This Addendum forms part of the Bid Documents and amends the Bid Documents as described below.

3. ARCHITECTURAL DETAILS - PROJECT MANUAL VOLUME 2

5. **ARCHITECTURAL DRAWINGS**

A1.1

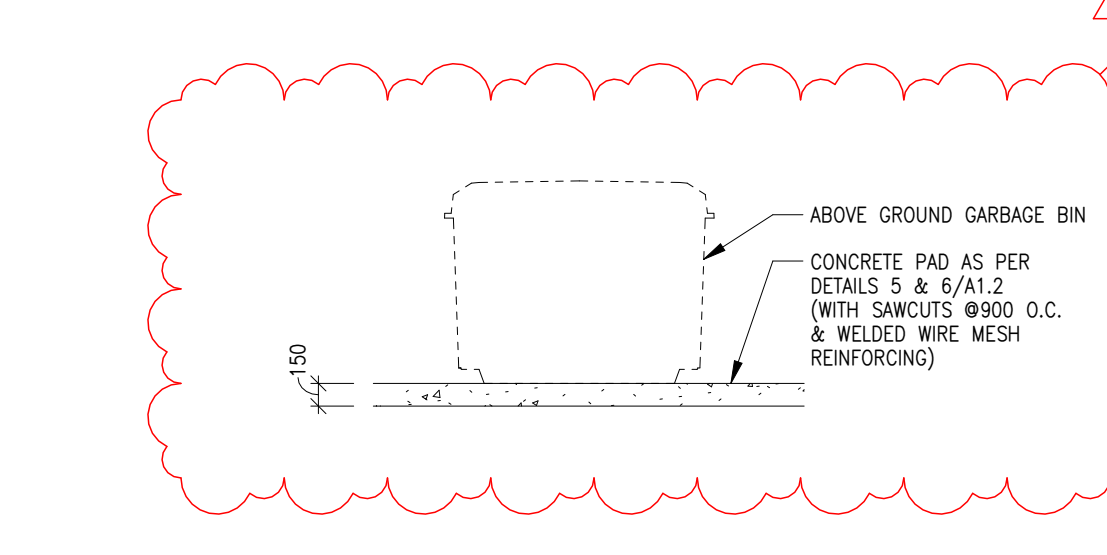
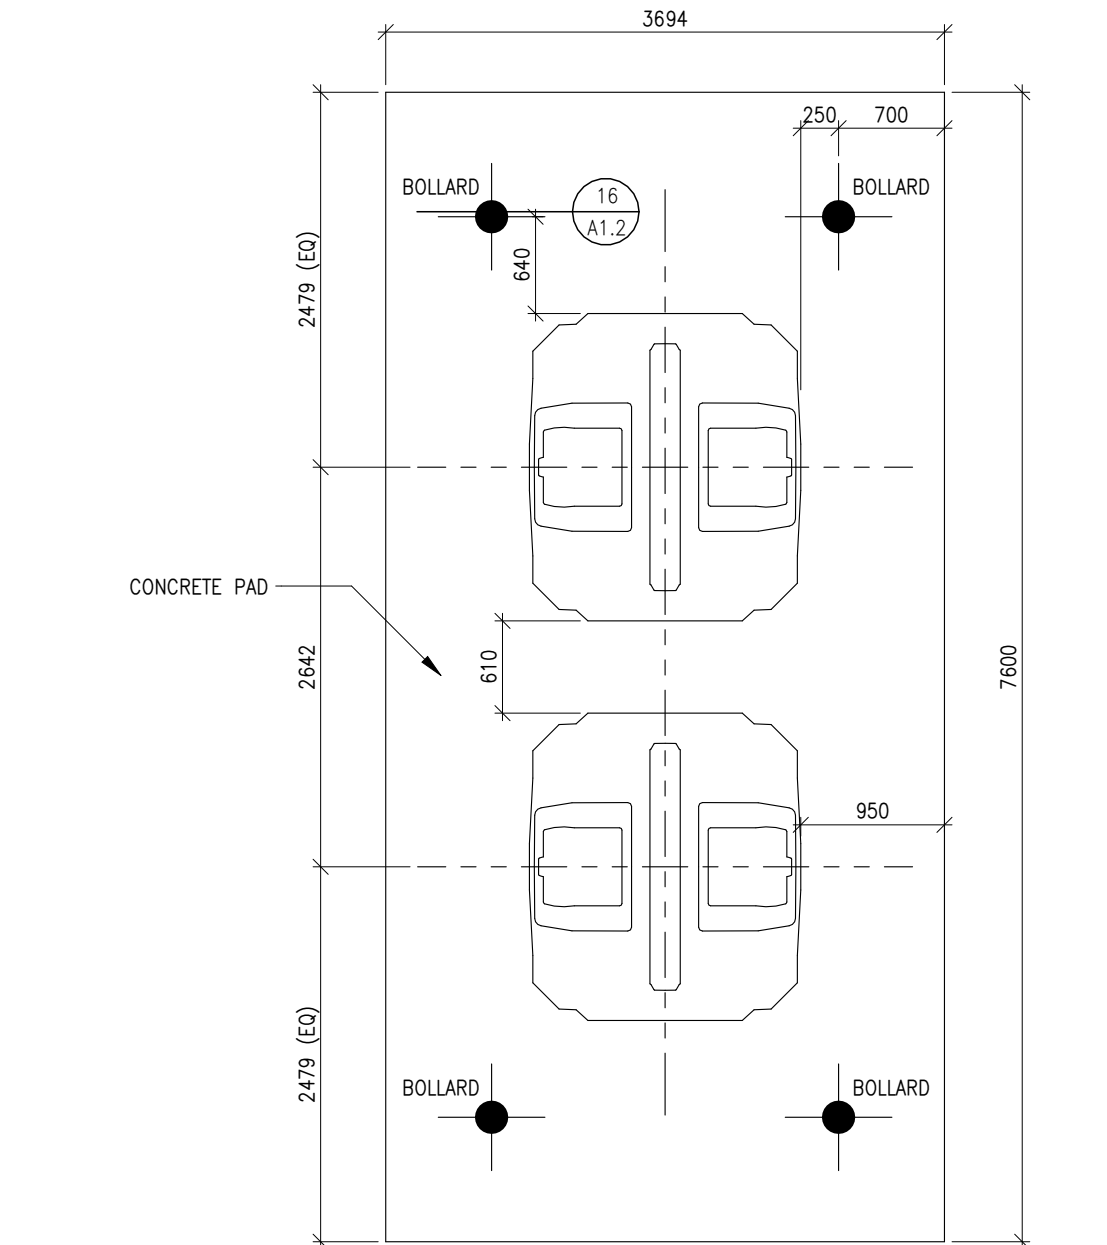
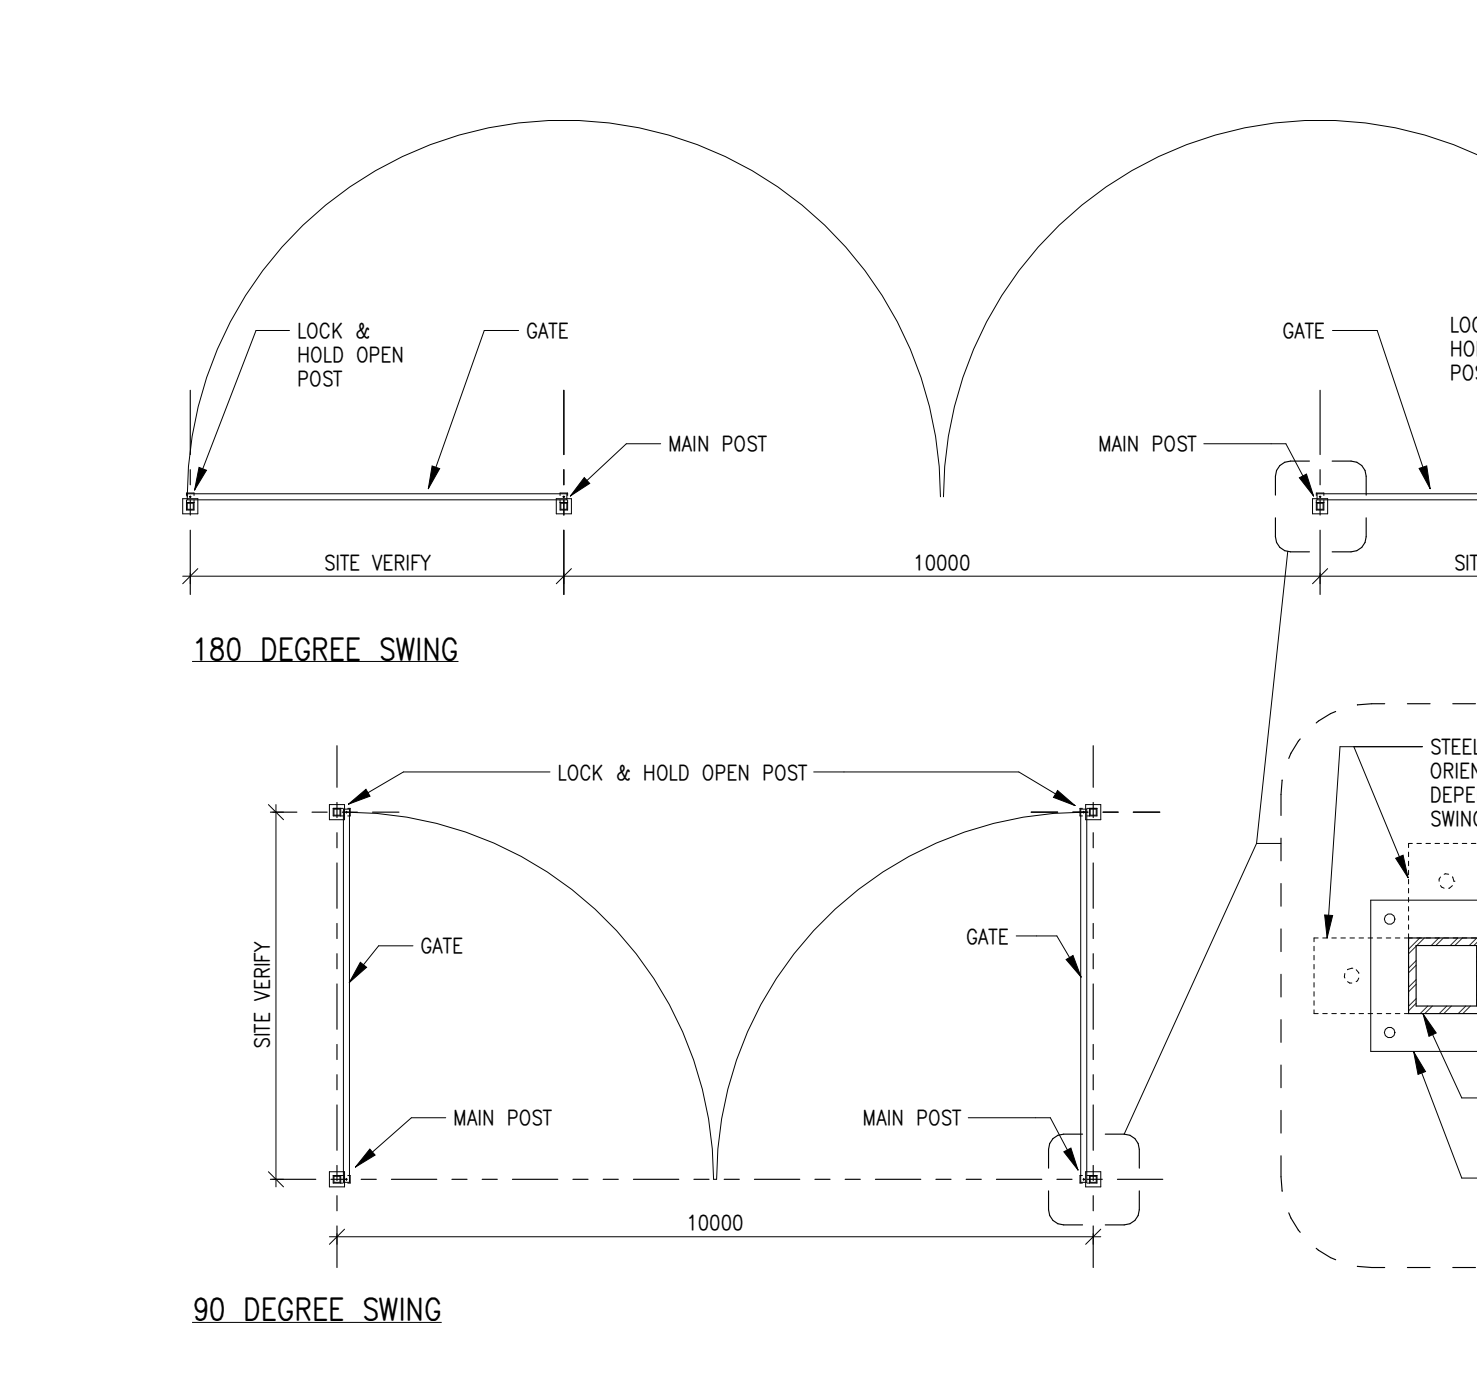
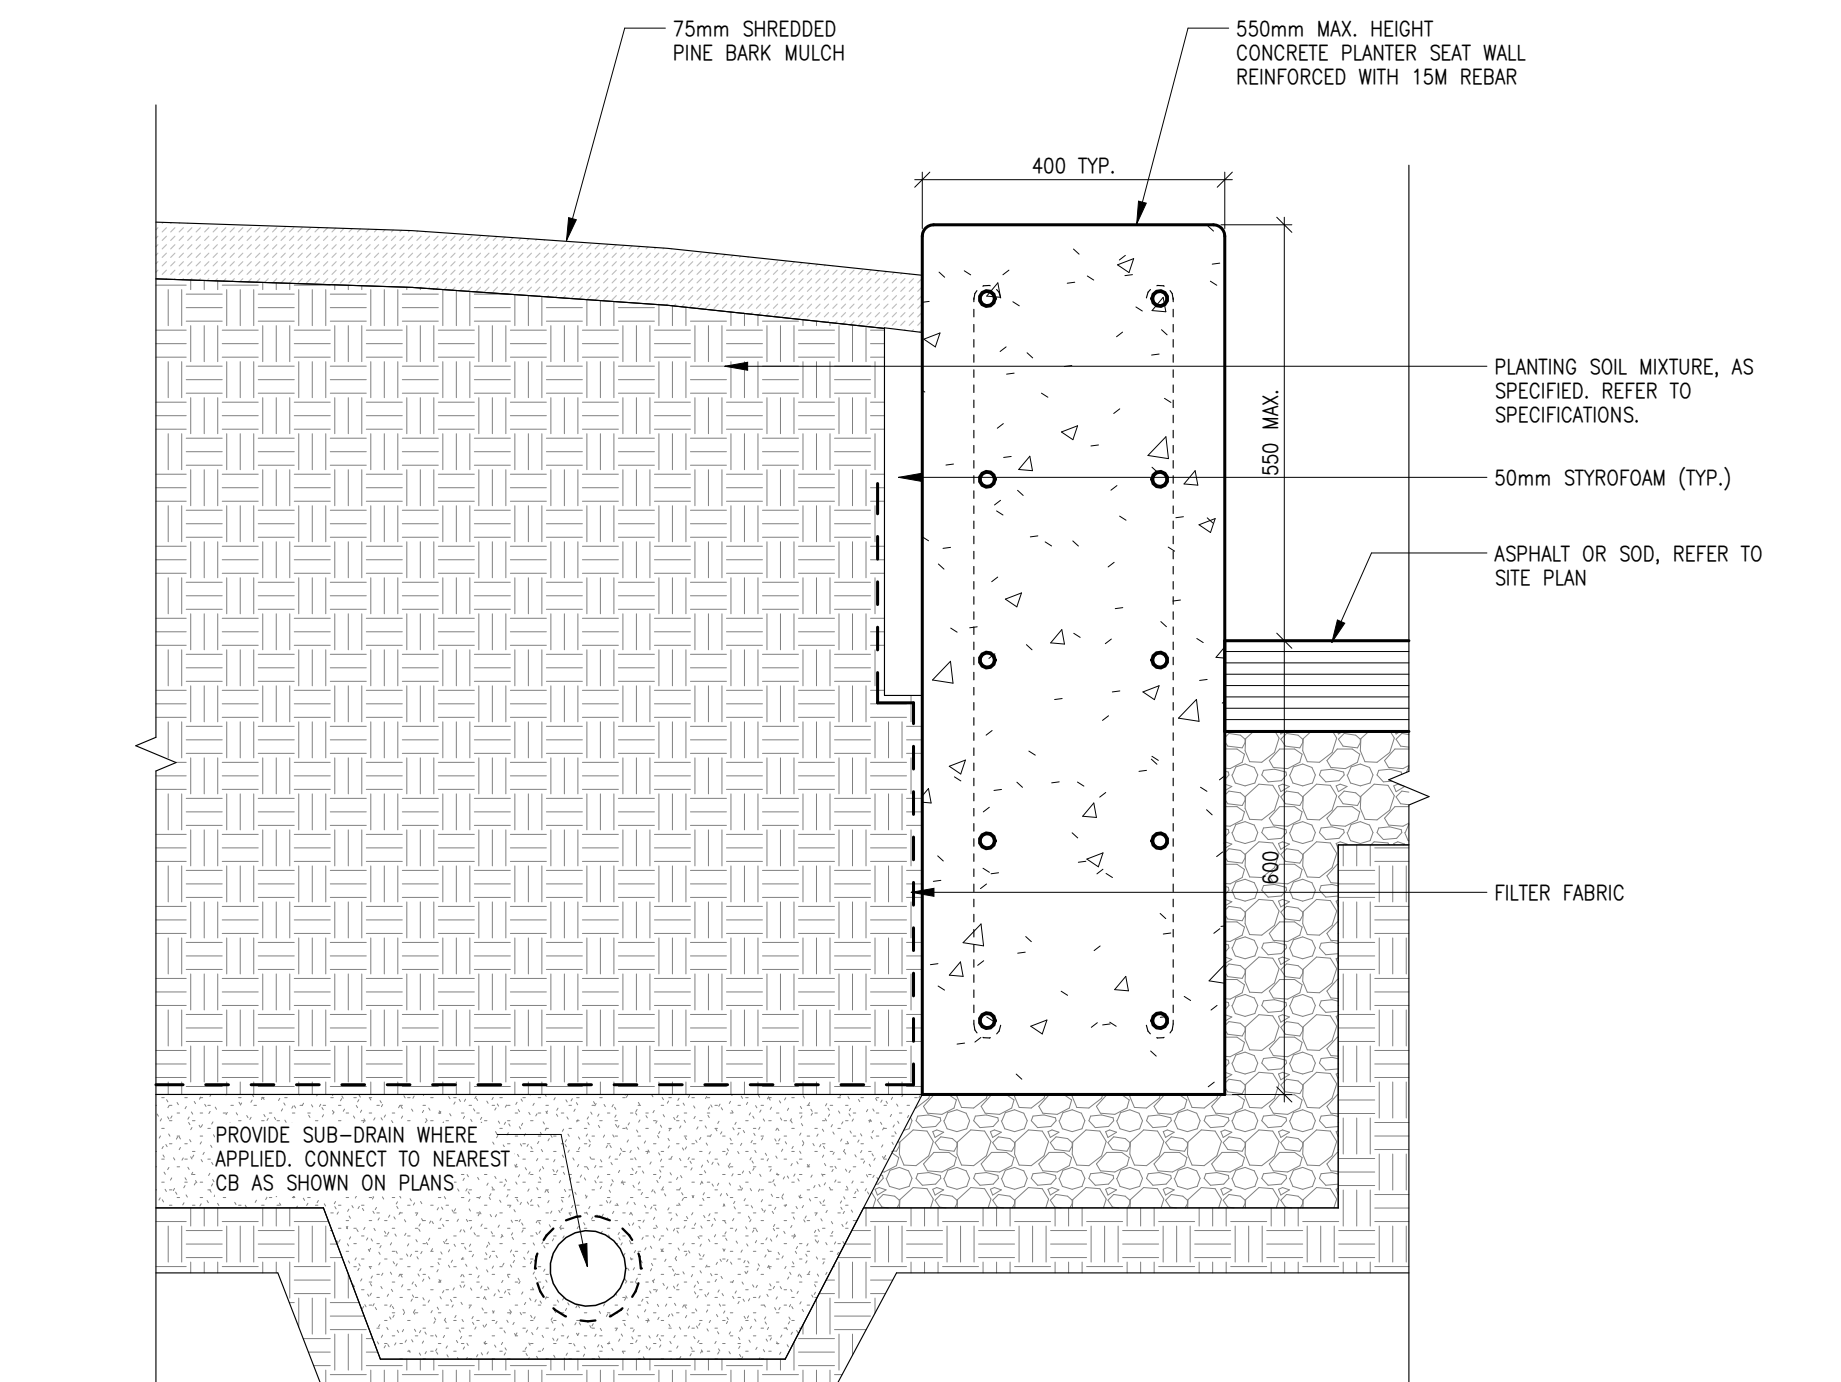
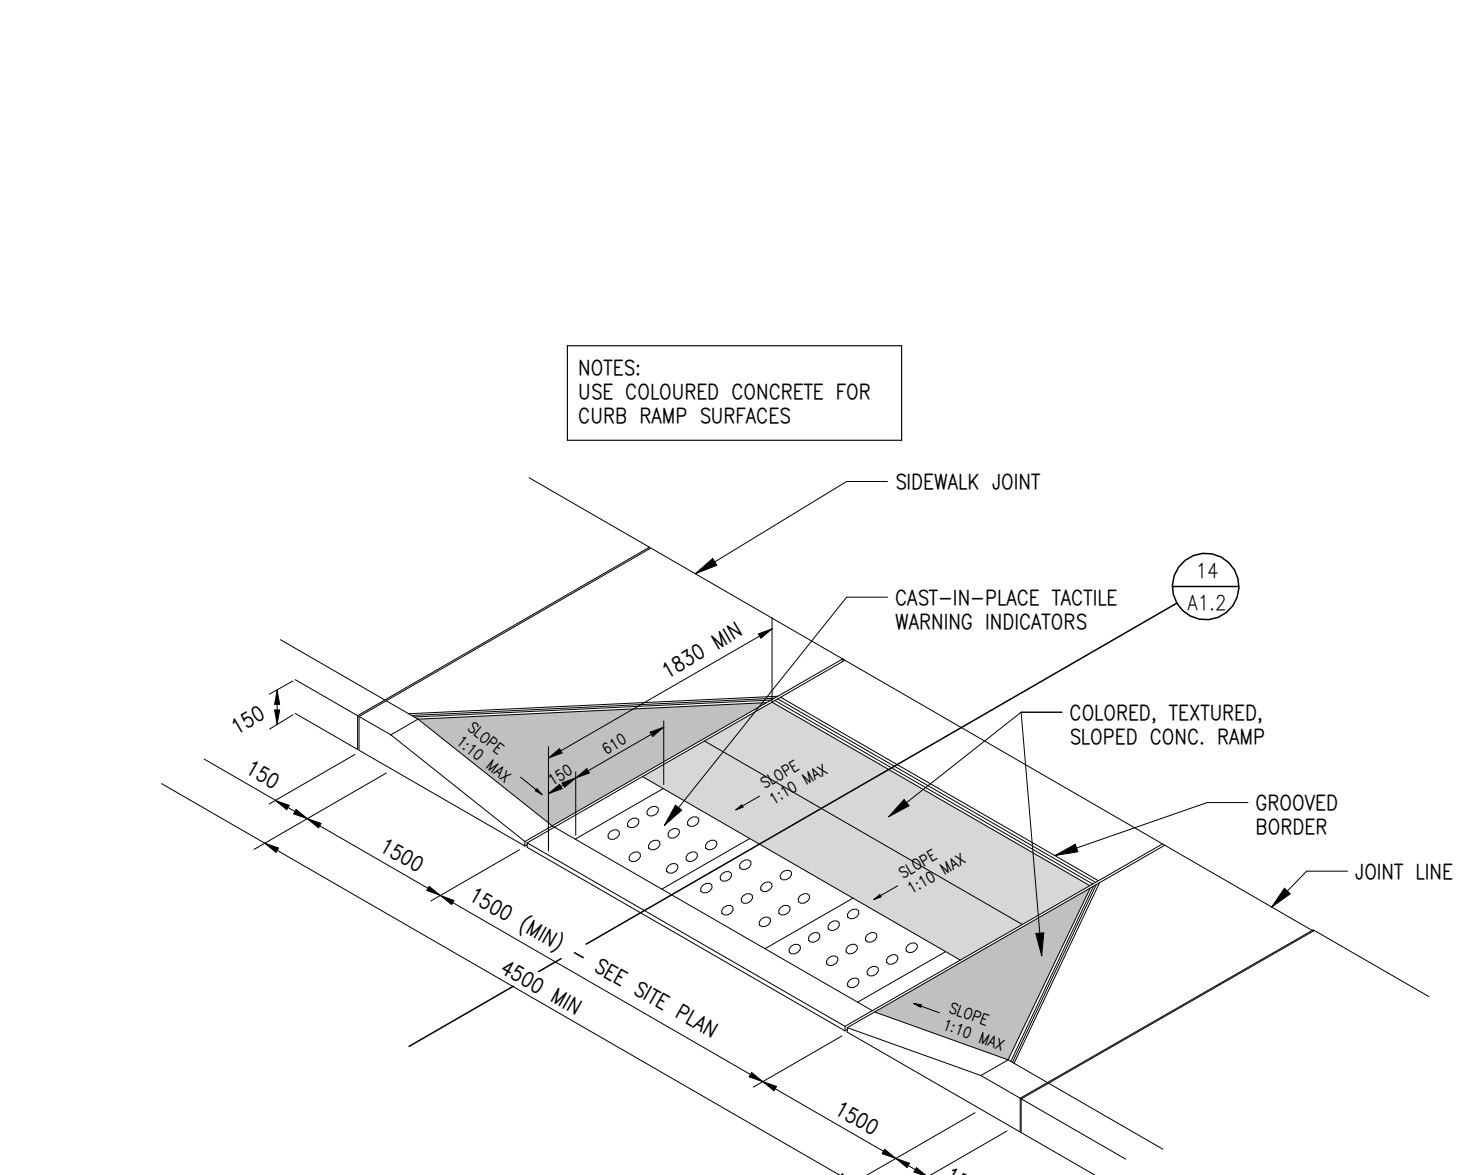
- .1 Callout for new details 31/A1.2 and 32/A1.2 added, as indicated in Sheet A1.1 issued with this Addendum.
- .2 Reference to "Below Ground Garbage Bin" replaced with "Above Ground Garbage Bin", as indicated in Sheet A1.1 issued with this Addendum.

- .1 Drawing 29/A1.2 revised from below-ground garbage bin to above-ground garbage bin, as indicated in Sheet A1.1 issued with this Addendum.
